Modification to run CPU09CMI on 4.5MHz bus.

On top side:

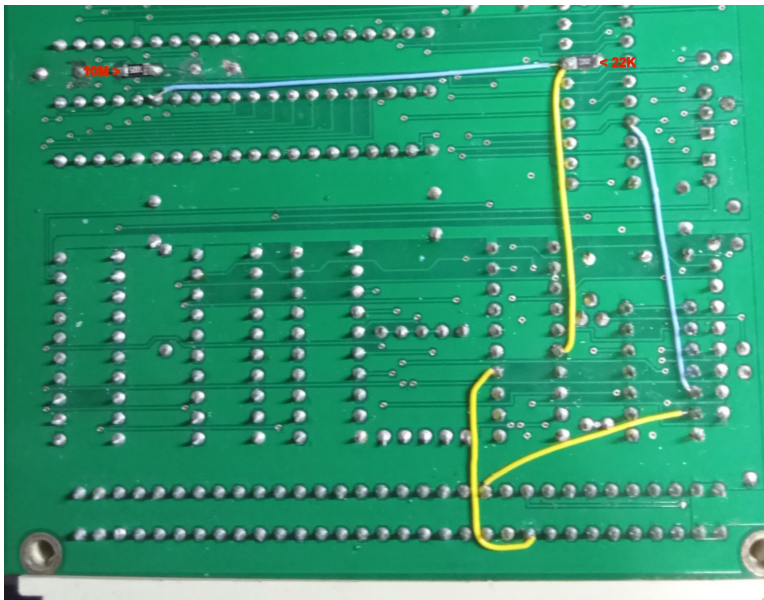
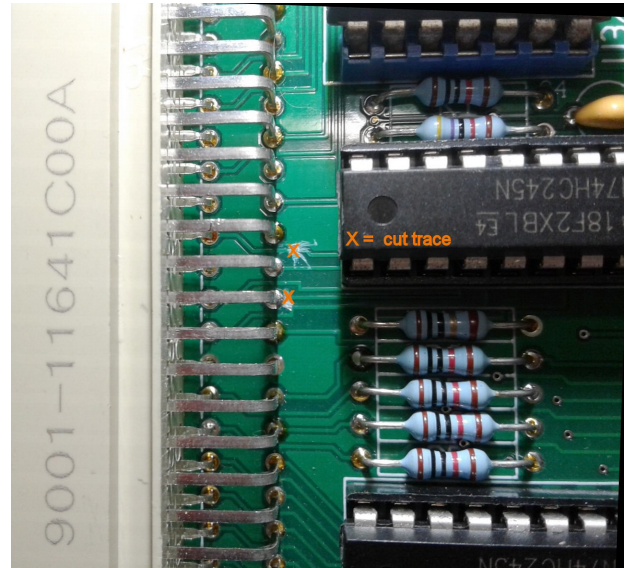
Cut trace between U4-14 and J1 C-21 (B_VMA-)

For REV:0.9 print only cut trace from J1 A23 to R15

On solder side:

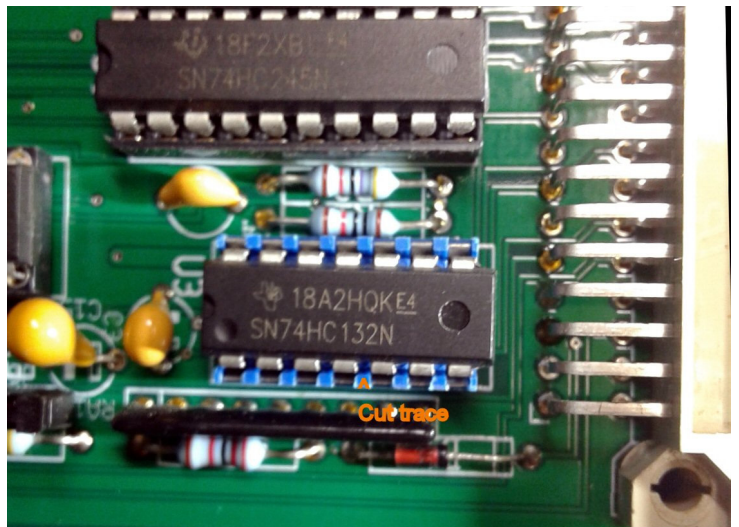
Cut trace between U13-19 and via (OVMA-)

Place 22K resistor between U13-19 and Gnd

Place wire from U6-35 to U13-19 (blue) and U4-6 (Q) (yellow)

Place wire from U4-14 to J1 A-23 (B_Q) (yellow)

Place wire from U3-7 to J1 C-21 (B_VMA-), Or:
**To keep CPU09CMI 68x02 compatible
or need VMA- signal with 68x02 on the bus
for CPU09GPP or CPU09RAM card.**
